Addressing the changes in Table 33-1 for supporting Type 3 and 4 PSEs Inrush.

9 **33.2.7.5 Output current in POWER_UP mode**

Figure 33-13— $I_{Inrush-2P}$ current and timing limits, per pairset in POWER_UP

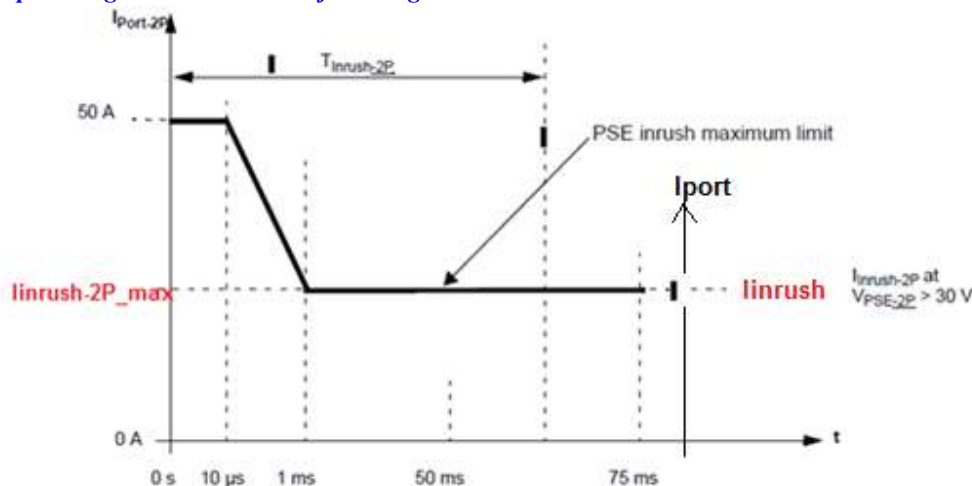
30 Figure 33-13 was modified to address the effect of end to end pair to pair resistance unbalance on the maximum limit of linrush-
31 2P which by simulation found to be 0.556A adding margin → 0.6Amax. This value will be updated in Figure 33-13 as well to
cover requirements below 1msec.

Replace Figure 33-13 with the following:

The PSE inrush maximum limit, $I_{PSEIT-2P}$, is defined by the following segments:

$$I_{PSEIT-2P}(t) = \left. \begin{array}{ll} 50.0 & \text{for } 0 < t < 10.0 \times 10^{-6} \\ \text{TBD=function of} & \text{for } 10.0 \times 10^{-6} \leq t < 0.001 \\ \text{(t, linrush-2P_max)} & \\ \text{linrush-2P_max} & 0.001 \leq t < 0.075 \end{array} \right\} \text{A} \quad (33-5)$$

Editor Note: To update the TBD in equation 33-5. Add Equation 33-5a after equation 33-5 to describe the template of figure 33-13 for linrush.
